The following information and check list are furnished as a guide for the insertion of new sheets for Amendment 24 into the Preliminary Safety Analysis Report for the Skagit/Hanford Nuclear Project. This material is denoted by use of the amendment date in the upper right hand corner of the page.

PUGET SOUND POWER & LIGHT COMPANY
SKAGIT / HANFORD NUCLEAR PROJECT
PRELIMINARY SAFETY
ANALYSIS REPORT

Figure 231.1-1

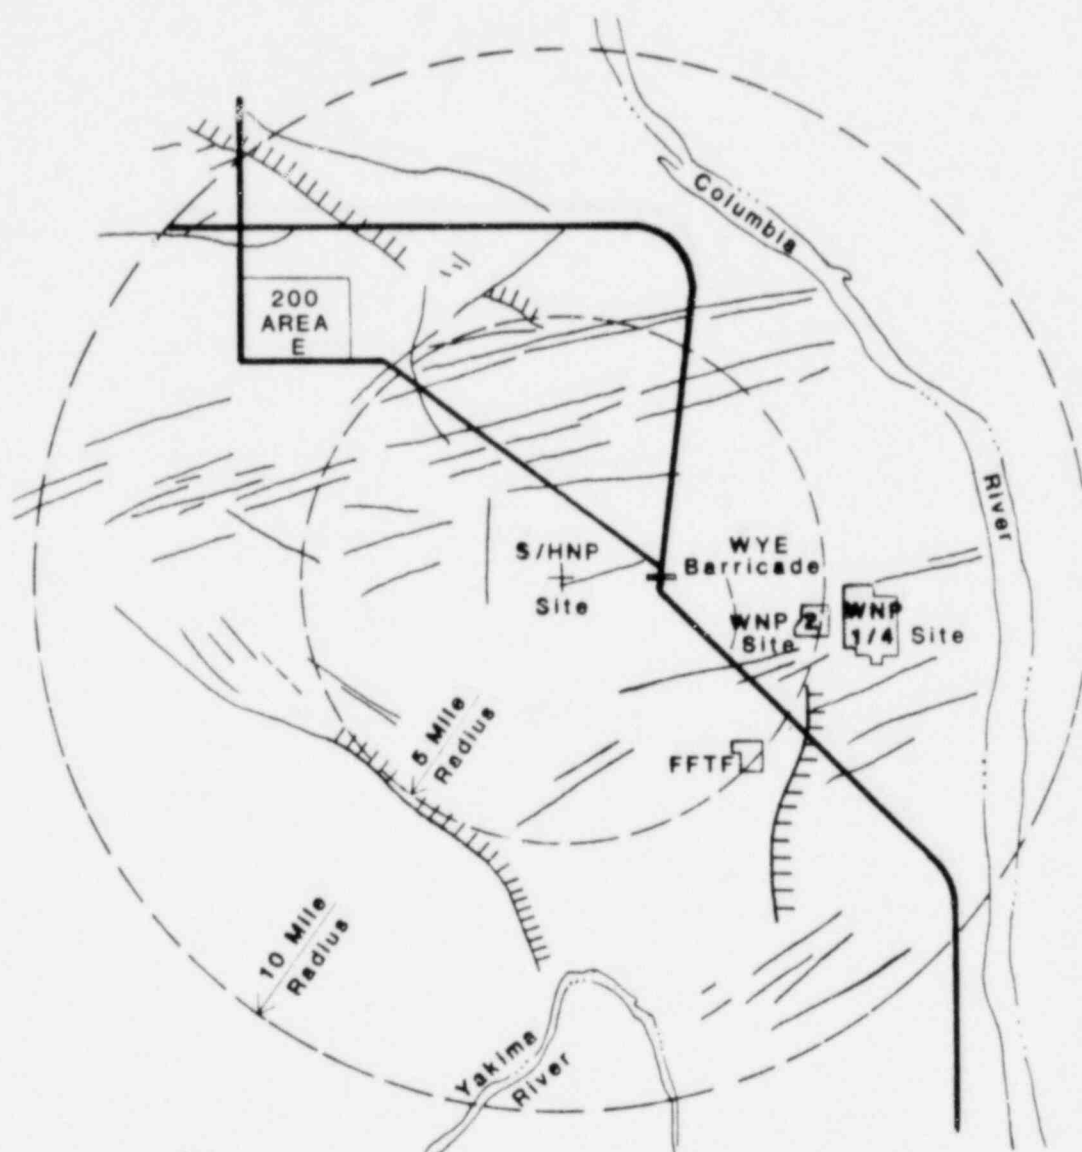
The analysis identified all linear features previously identified by Glass (1977) and Slemmons and O'Malley (1979 - 1980) within 10 miles of the Site, and several additional lineaments which had not been noted by previous workers (Figure 231.1-1).

Figure 231.1-2

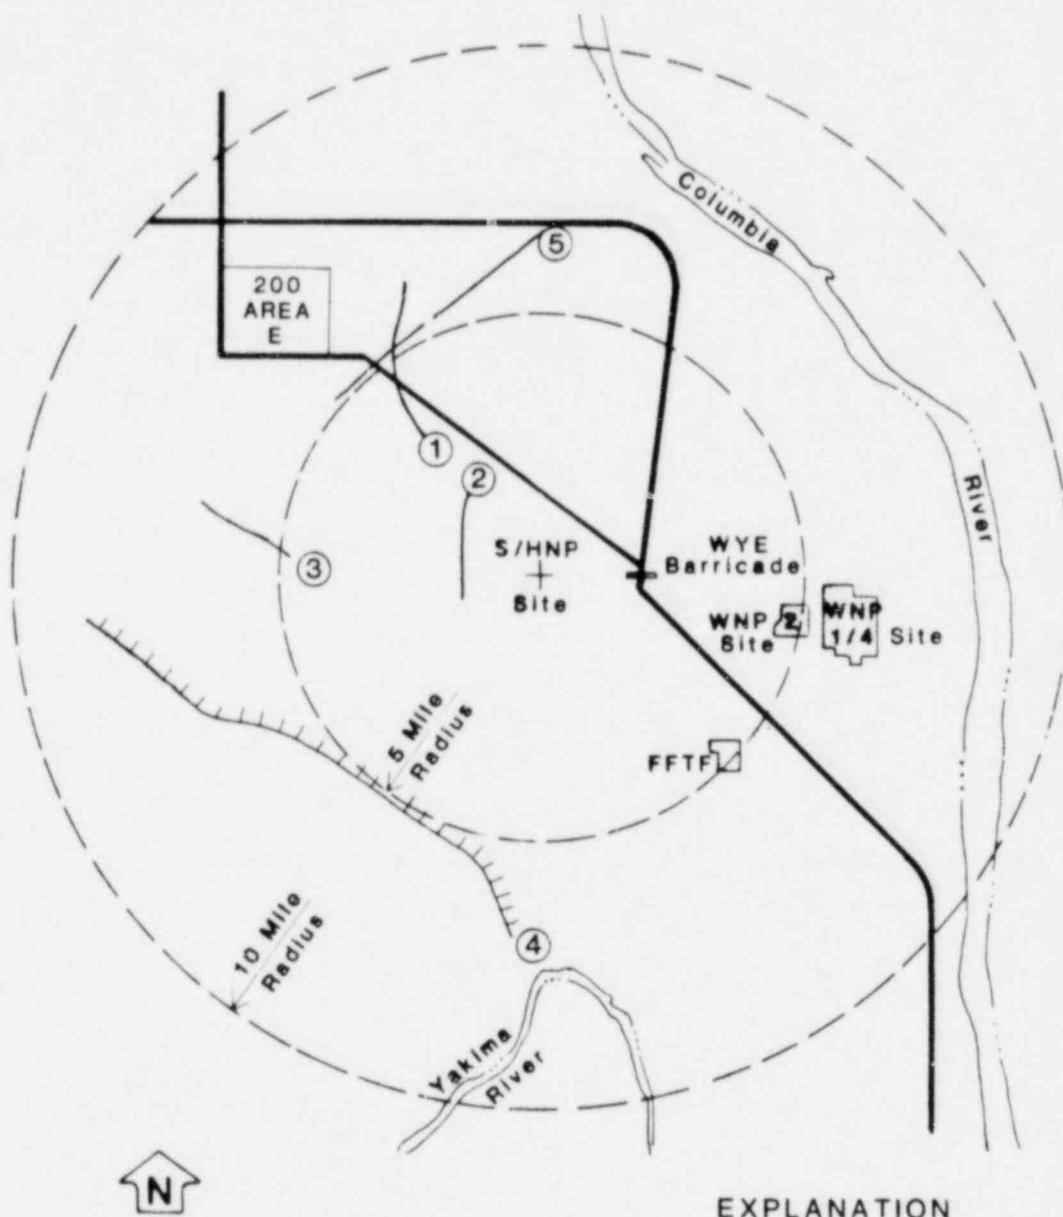
Lineaments which could not, by inspection of the imagery, be assigned either to previously mapped geologic structure or to one of the three origins noted above (Figure 231.1-2) were specifically field checked. The characteristics and origins of these lineaments are discussed below.

One photolineament has been identified in the vicinity of Werner solution D-29 (Figure 231.1-2, Feature 3), which corresponds in trend and location with the northern flank of the Yakima Ridge extension shown on Figure 8-3 of Rockwell (1981). The Werner solution has probably been

Figure 231.1-3

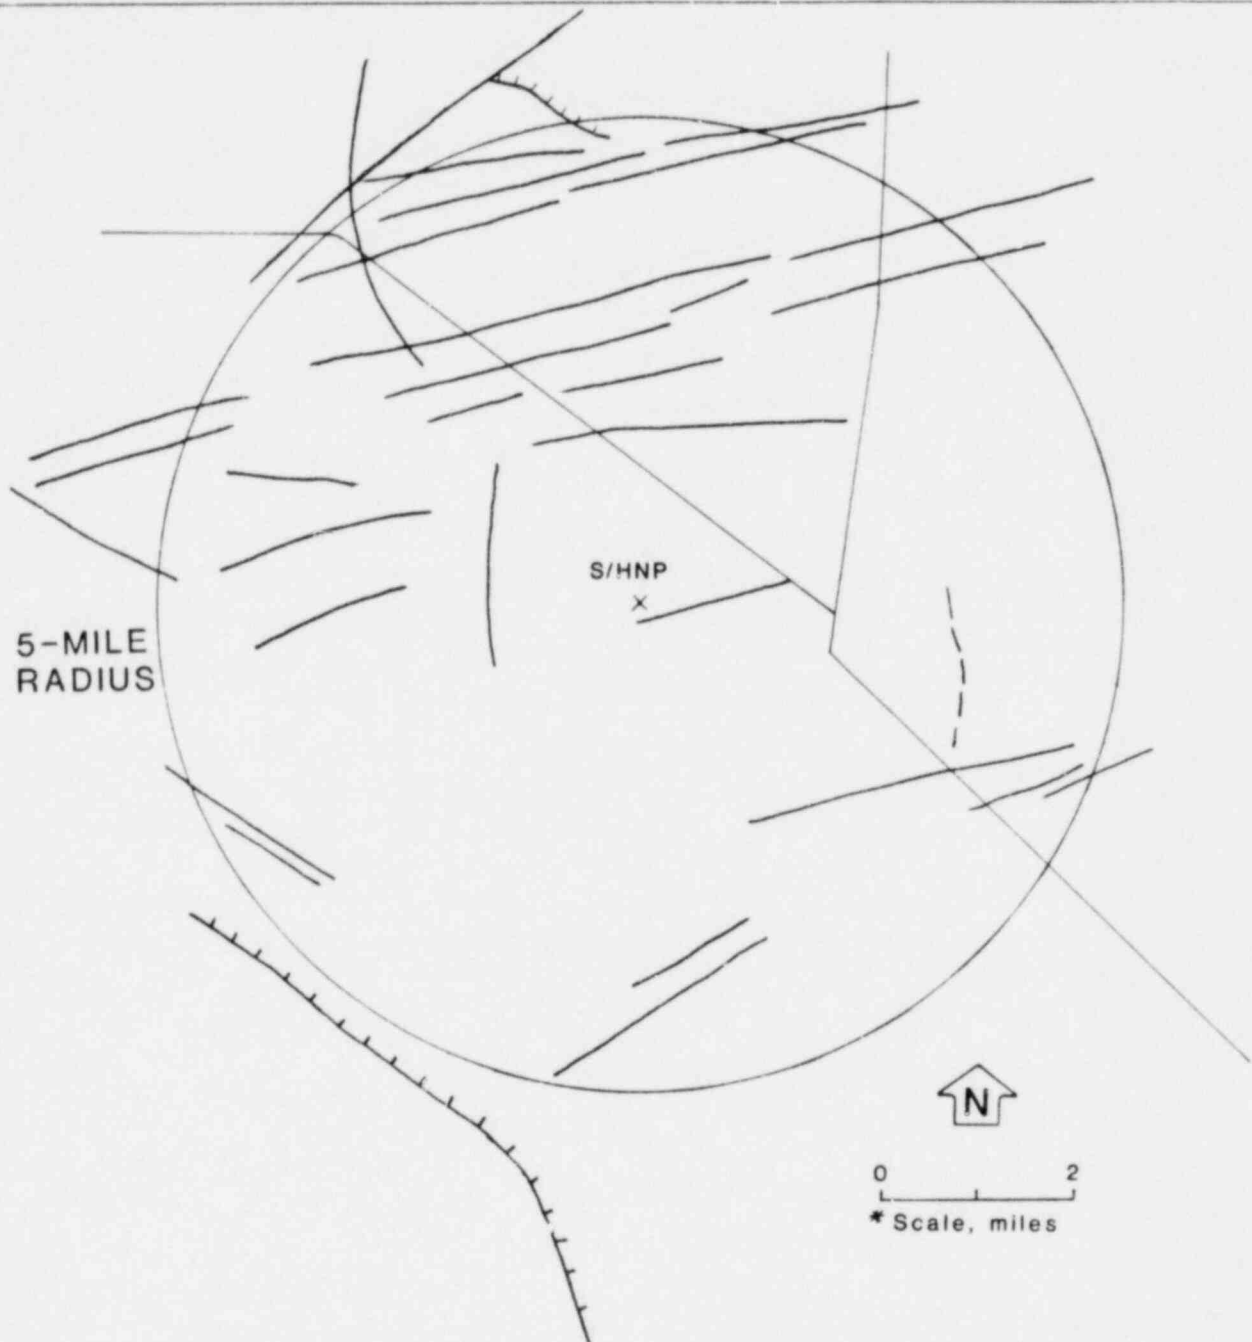
Although examination of the imagery and field checking of specific features indicated no evidence of structural control for any of the photolineaments within a five-mile radius of the site (Figure 231.1-3), a comparison has also been made with bedrock contour maps (Figure 2R-7, Appendix 2R, S/HNP Amendment 23, 1981; Figure 8-3, Rockwell, 1981; and Figure 111-4a, Rockwell, 1979). With only three exceptions, there is no correspondence between the photolineaments and bedrock topography. These three exceptions occur in the vicinity of Werner solutions shown on Rockwell Figures B-11 and B-12 (1981), and are described below in terms of the location of these solutions.
